AMBERLEIGH SHORES

NEW HANOVER COUNTY, NC

LAST REVISED - 12/05/12 (REV 14)

FLOURNOY DEVELOPMENT COMPANY
NEW HANOVER COUNTY, NC
AMBERLEIGH SHORES
PLAN REVISION SUMMARY

G1.2

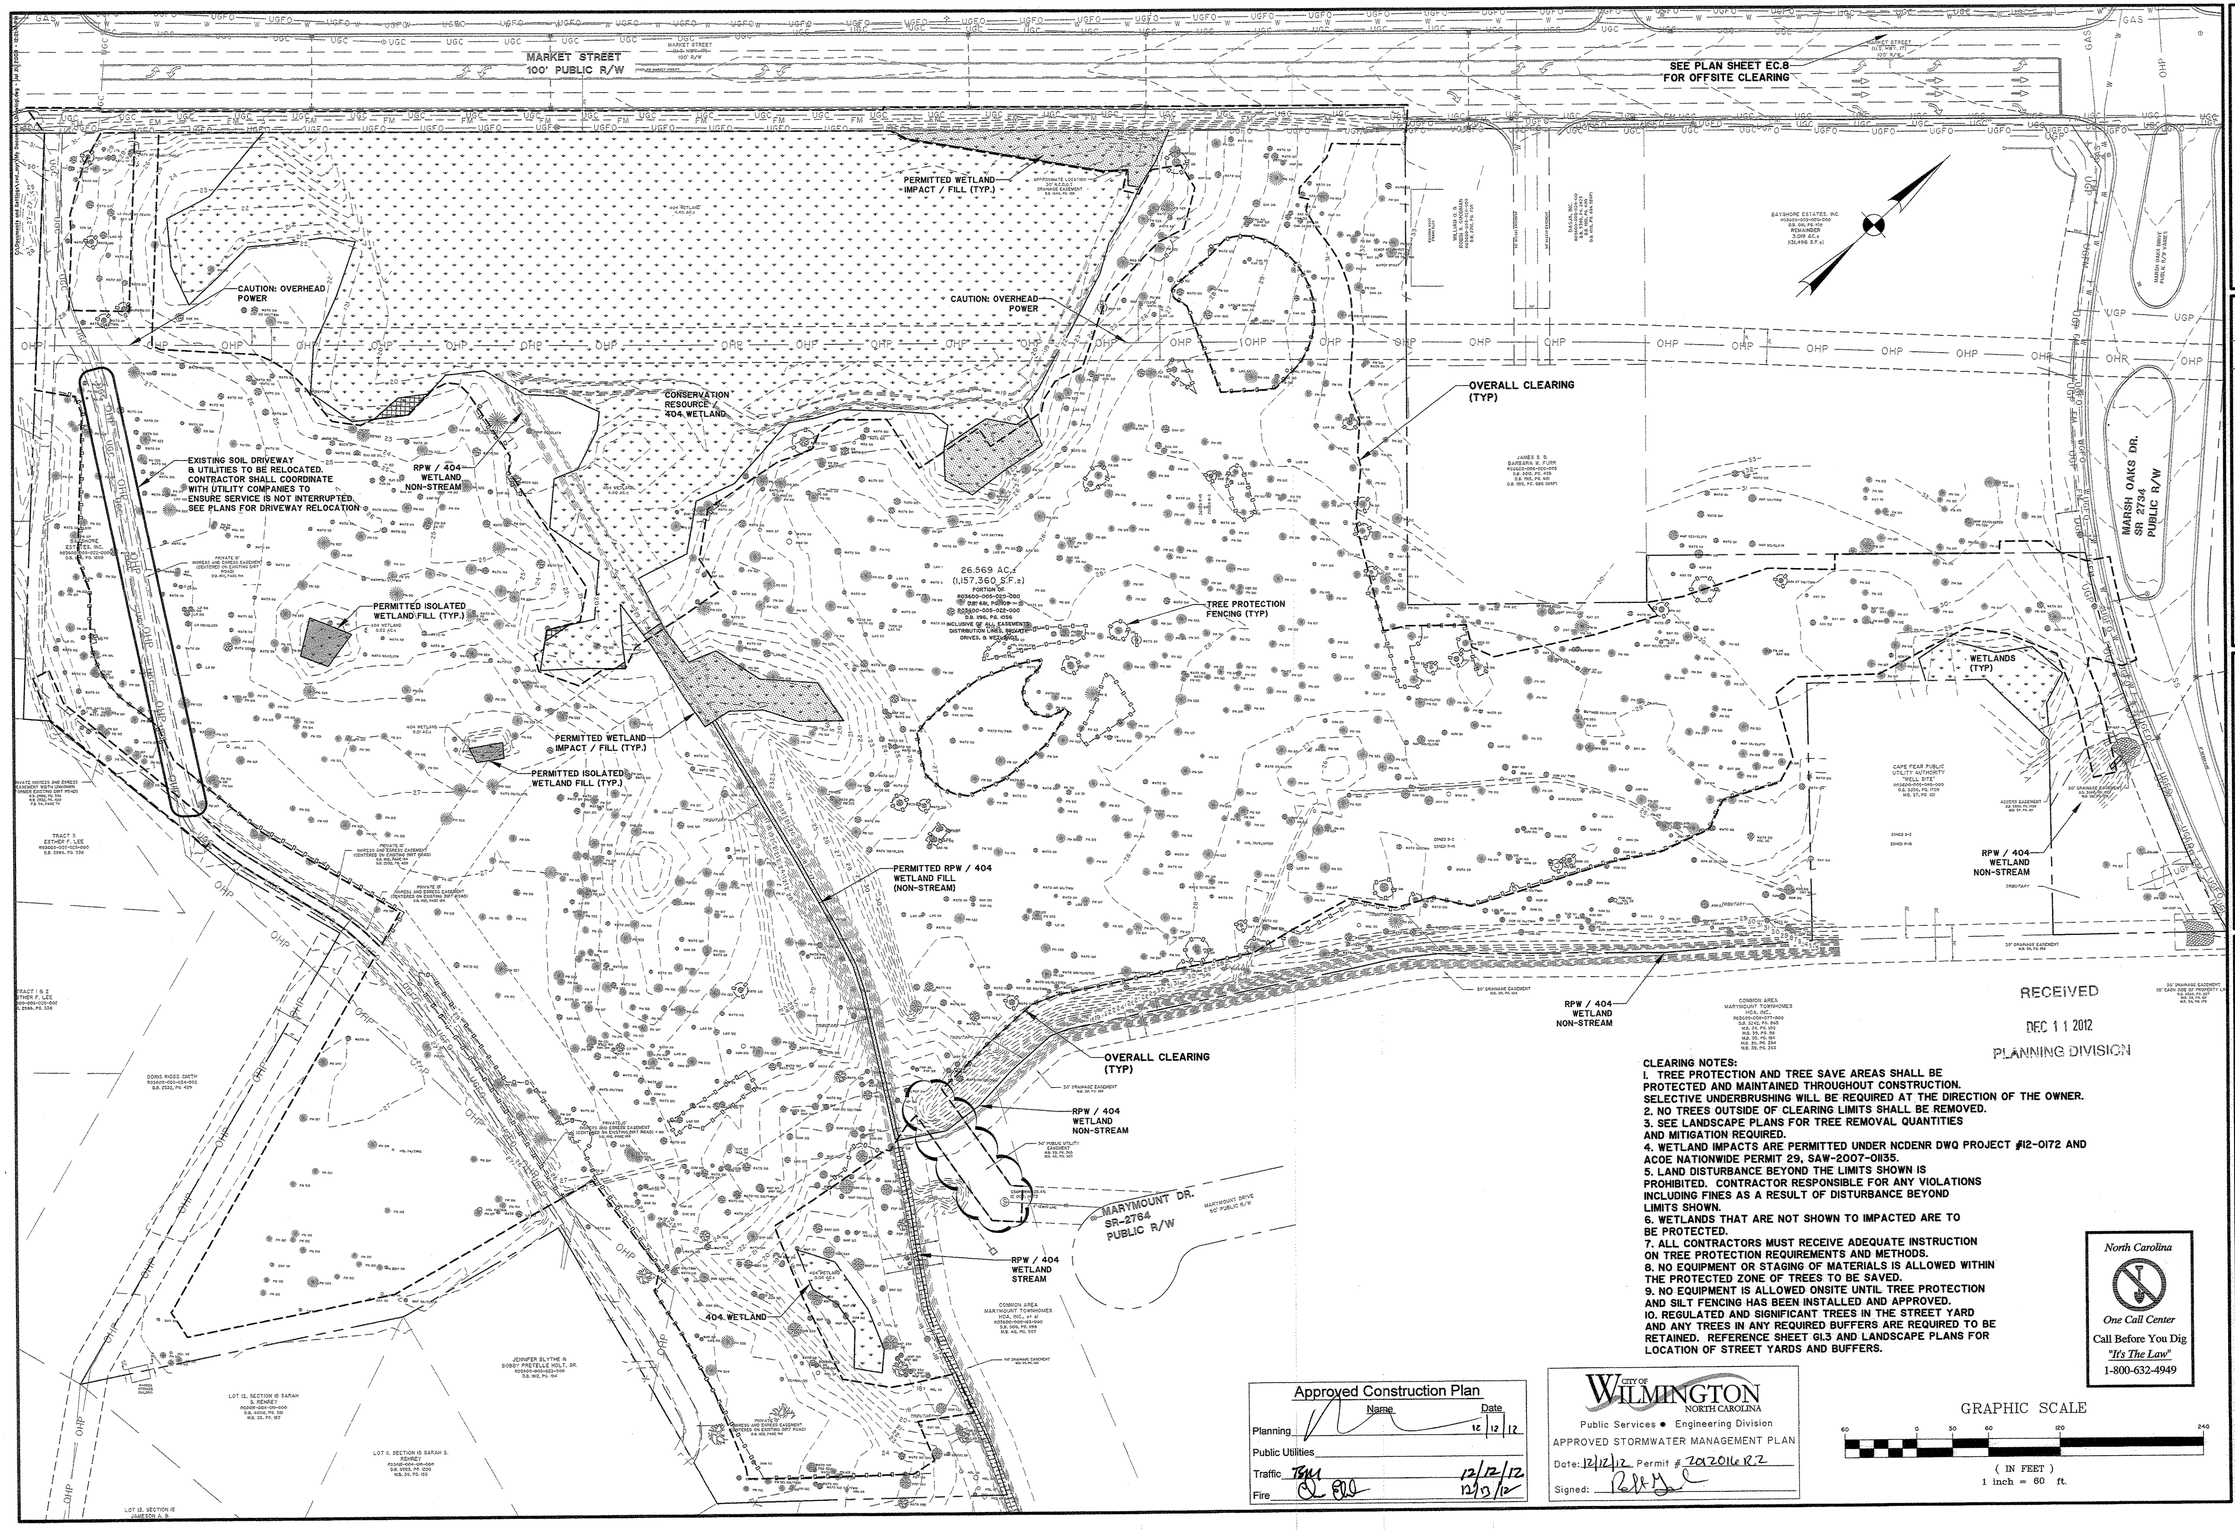
Sheet No.	Revision Comment
C00	Update Schedule of Drawings. Add sheet G1.3.
G1.1	Update General Notes, Project Information & Project Contacts.
G1.2	Increase clearing limits along Marsh Oaks Drive and add additional tree protection.
G1.3	Add Overall Concept Plan with required City of Wilmington Development Data notes. Adjust playground location. Add dog parks behind Garage C and across from Building 9 including additional sidewalks for access. Relocate compactor access to rear. Reduce size of u-turn bulb out on Market based on "SU" truck turning radii.
C1.0-C1.8	Adjust playground location. Add dog parks behind Garage C and across from Building 9 including additional sidewalks for access. Relocate compactor access to rear. Reduce size of u-turn bulb out on Market based on "SU" truck turning radii. Delete asphalt on Market Street right north bound lane. Add additional dimensions on Market St. per NCDOT requirements. Miscellaneous label revisions. Revise perimeter fence types. Graphically show detectable warning strips. Remove Accessible parking at playground per FDC. Add 24" thermoplastic stop bar & remove turn arrows at Marsh Oaks Entrance.

14 REVISE CLEARING LIMITS
13 UPDATE CLEARING LIMITS ON NE CORNER OF SITE
12 ADD PREVIOUS REVISION NOTES
10 SEE REVISION SUMMARY ON SHEET G1.0
9 REVISE CLEARING LIMITS FOR EMERGENCY ACCESS ROAD
6 UPDATE CLEARING/DISTURBANCE LIMITS
4 SEE REVISION SUMMARY ON SHEET G1.0
1 SEE REVISION SUMMARY ON SHEET G1.0

G1.3

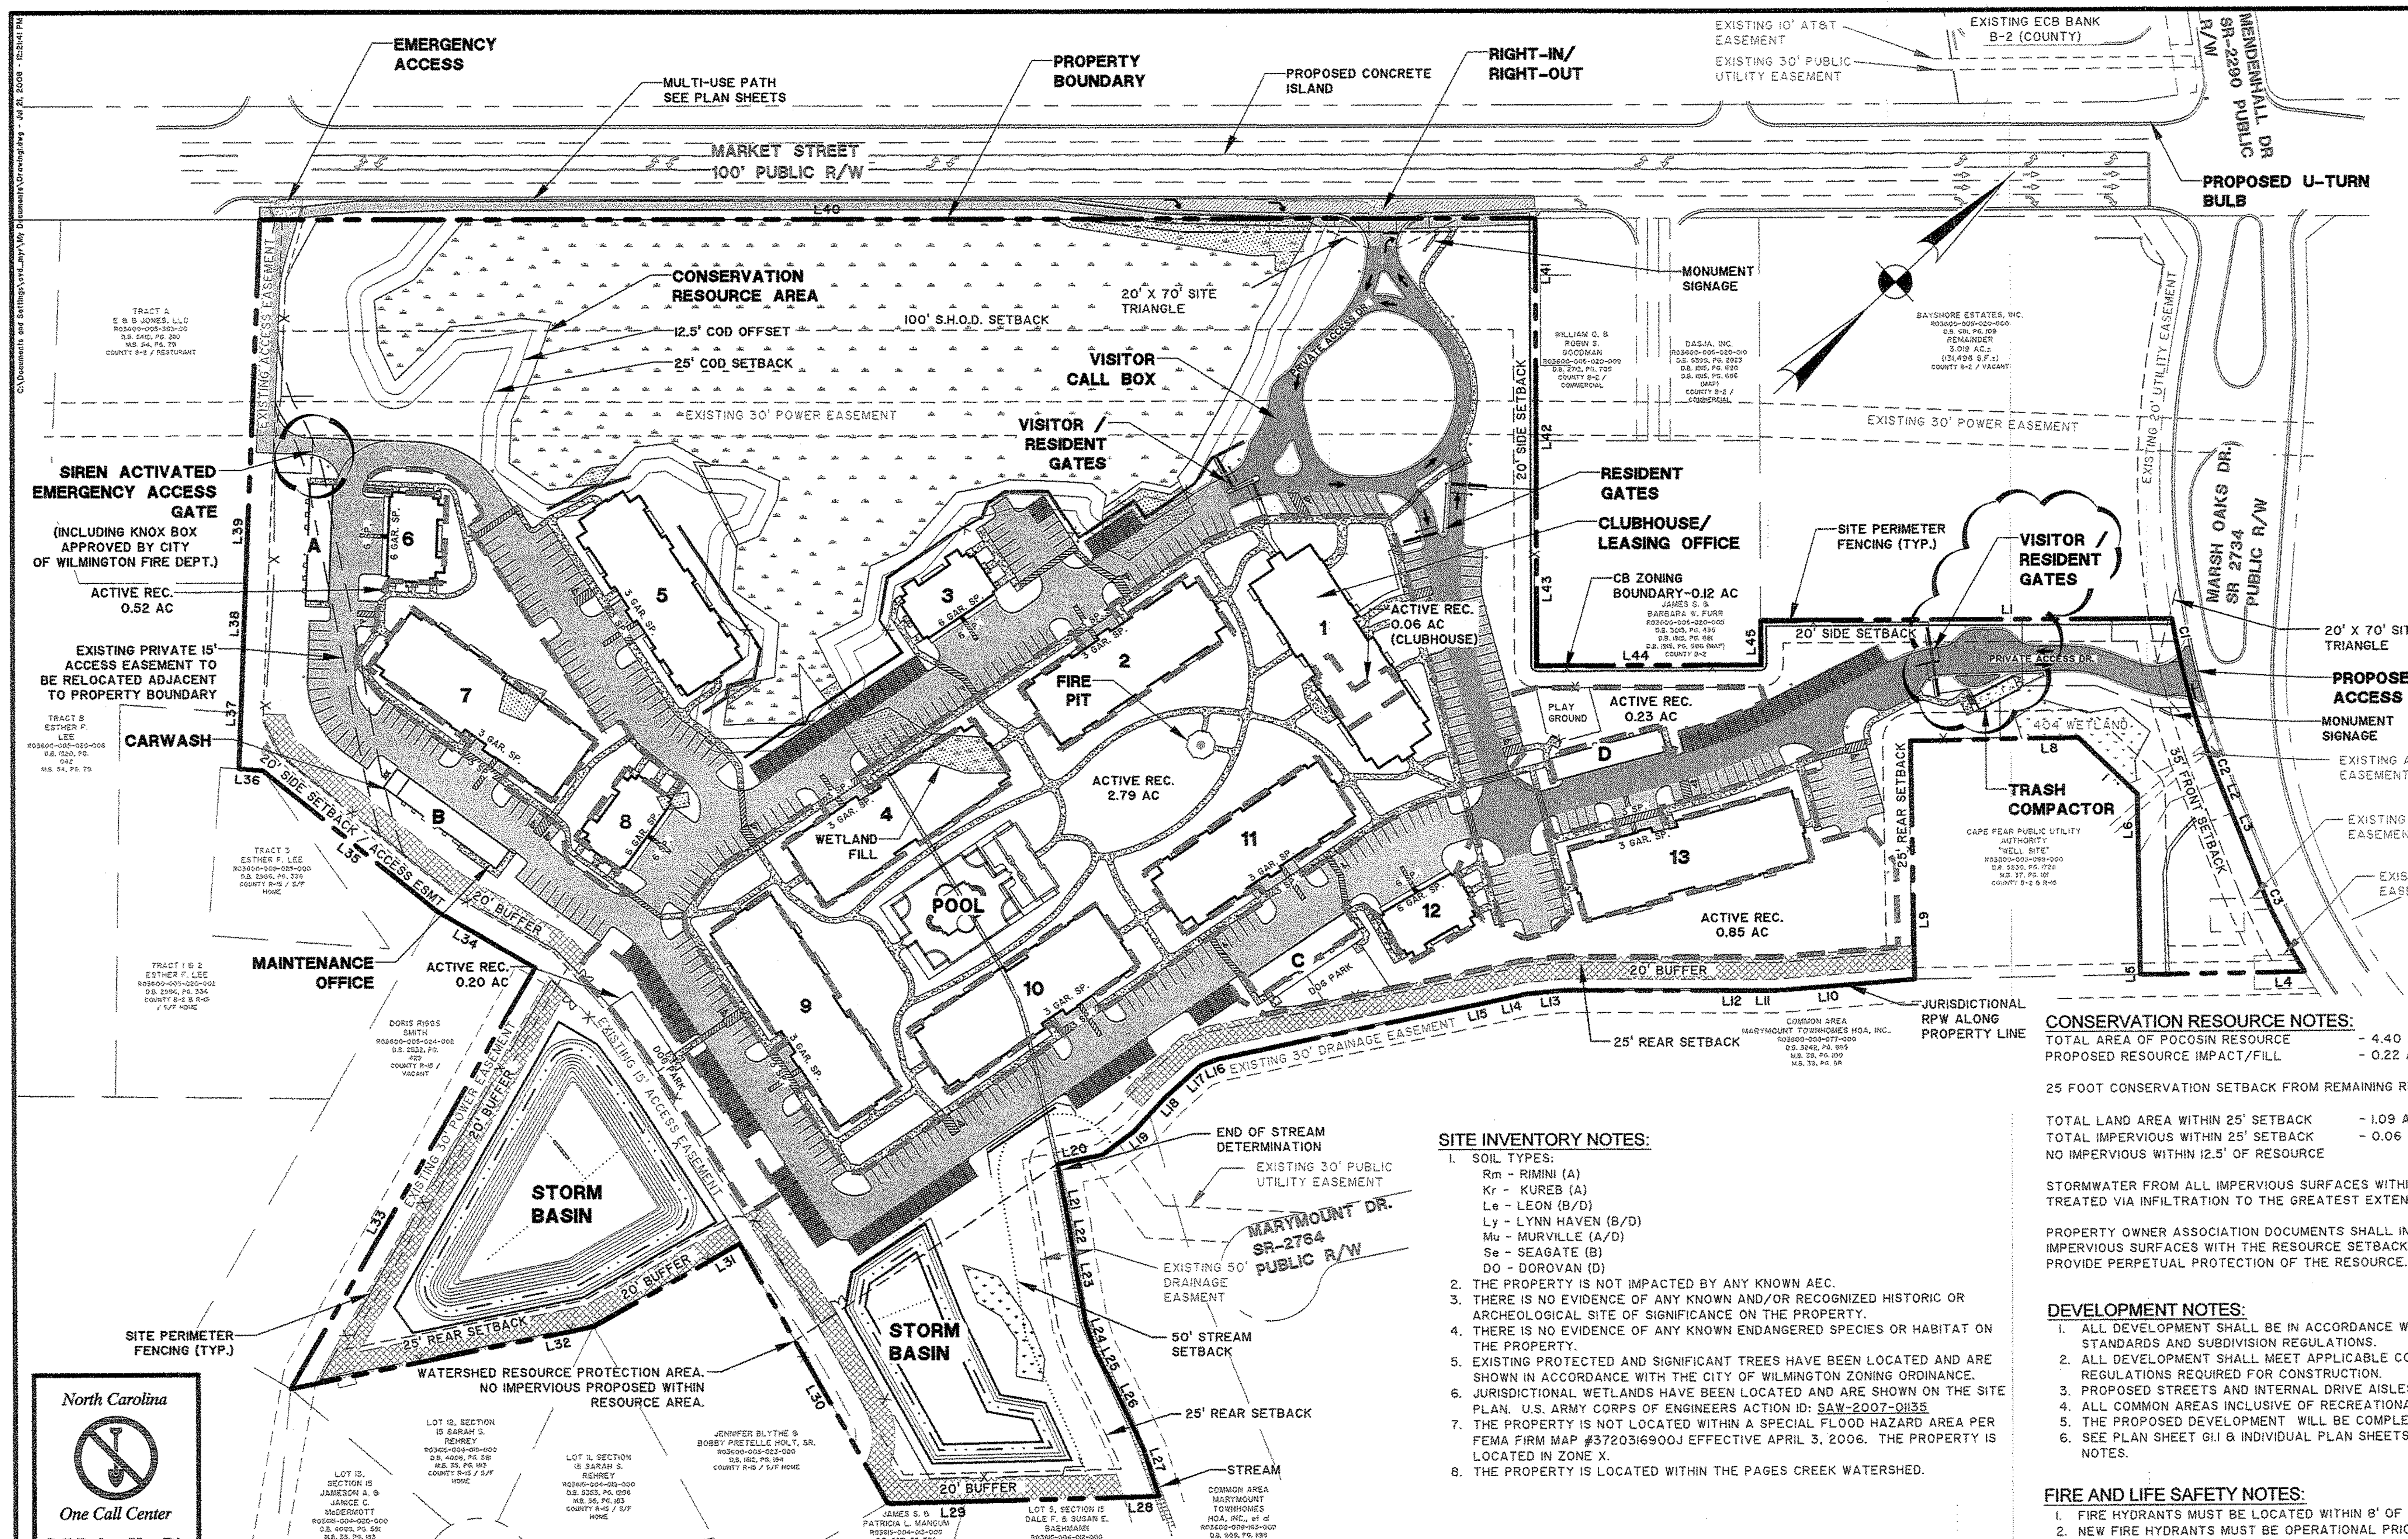
Sheet No.	Revision Comment
G1.0	Add Revision 9 Summary
G1.1	Update Project Map to show revised Emergency Driveway location.
G1.2	Update clearing limits based on revised Emergency Driveway location.
G1.3	Update to show revised Emergency Driveway location.
C1.0	Update to show revised Emergency Driveway location.
C1.9	Update Emergency Driveway location & associated dimensions.
EC.0	Update to show revised Emergency Driveway location.
EC.9	Update silt fence based on revised Emergency Driveway location.
C2.0	Update to show revised Emergency Driveway location.
C2.3	Update to show revised Emergency Driveway location.
C3.0	Update to show revised Emergency Driveway location.
C3.9	Revise spot grades on Emergency Access driveway apron.
C5.0	Update to show revised Emergency Driveway location.

C1.8

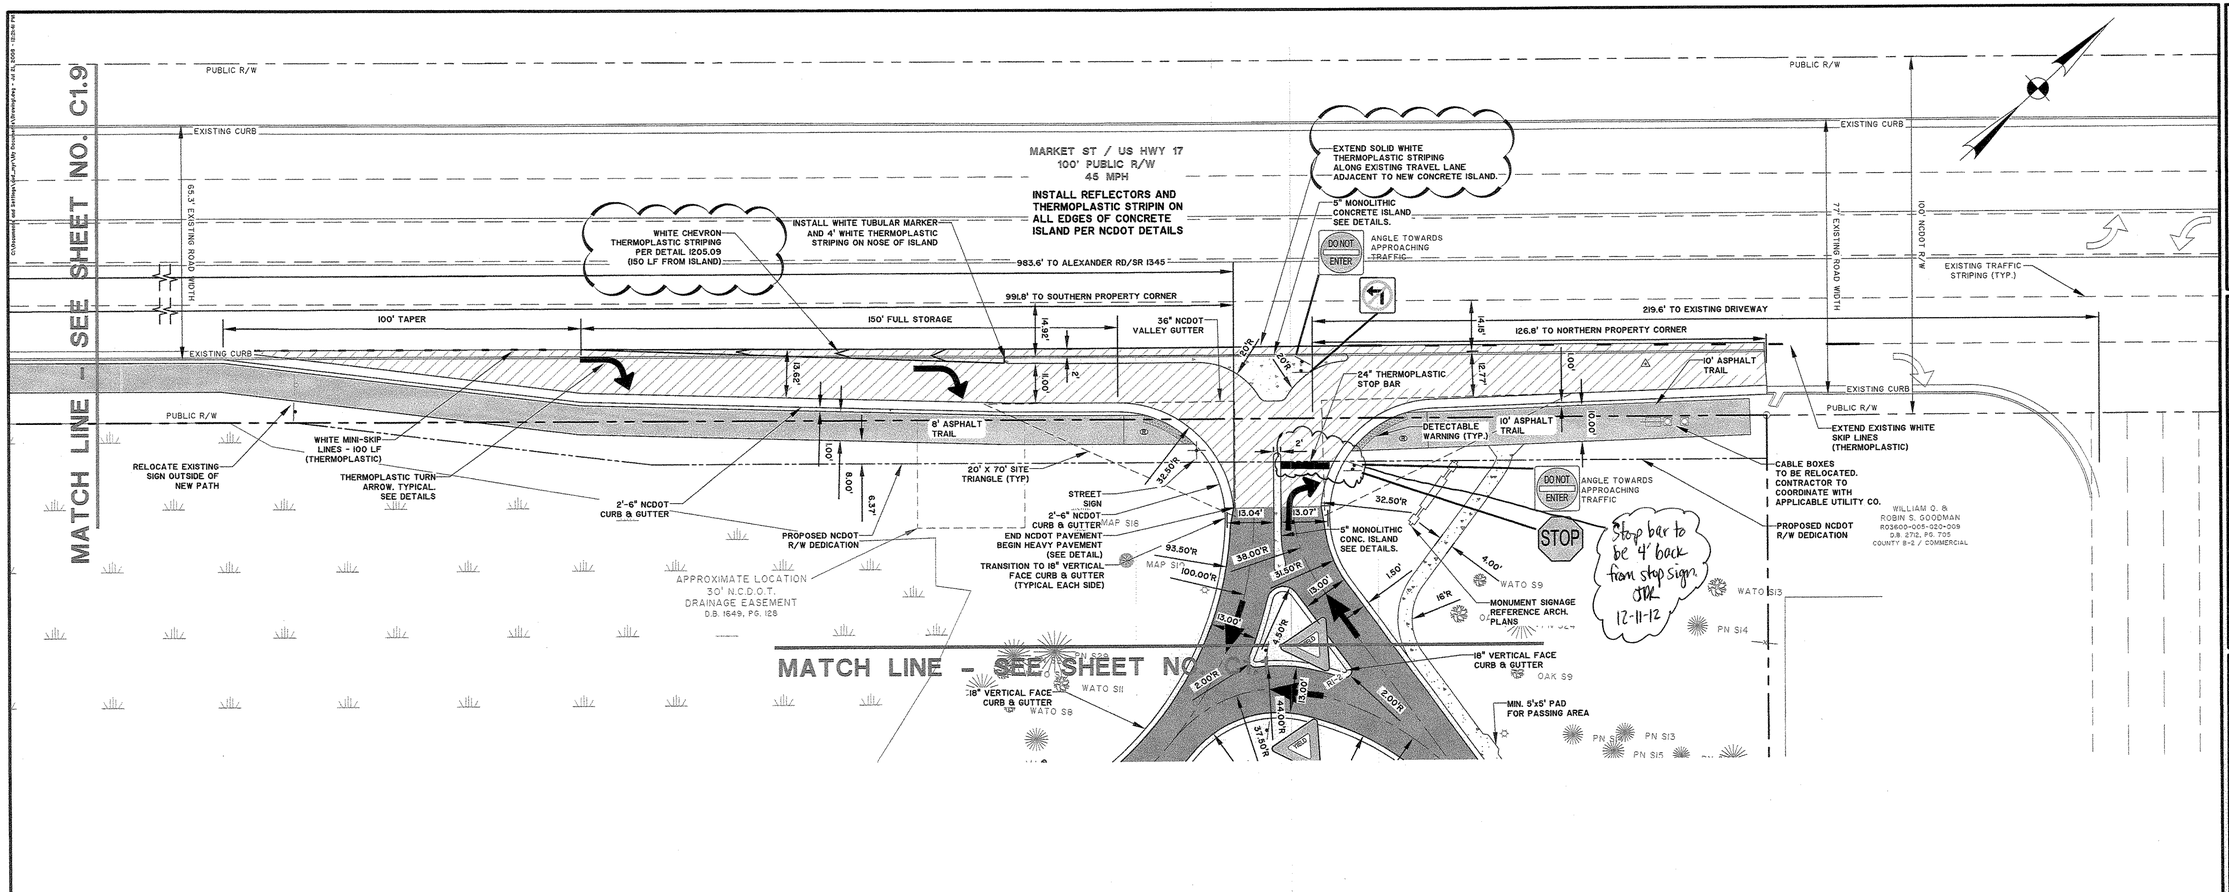
NO.	REVISIONS	BY	DATE
14	REVISE TURN LANE STRIPING PER NCDOT PERMIT	BDR	12/05/12
12	ADD PREVIOUS REVISION NOTES	BDR	09/27/12
6	SEE REVISION SUMMARY ON SHEET 8.0	BDR	05/18/12
4	SEE REVISION SUMMARY ON SHEET 8.0	BDR	04/23/12
1	SEE REVISION SUMMARY ON SHEET 8.0	BDR	01/23/12
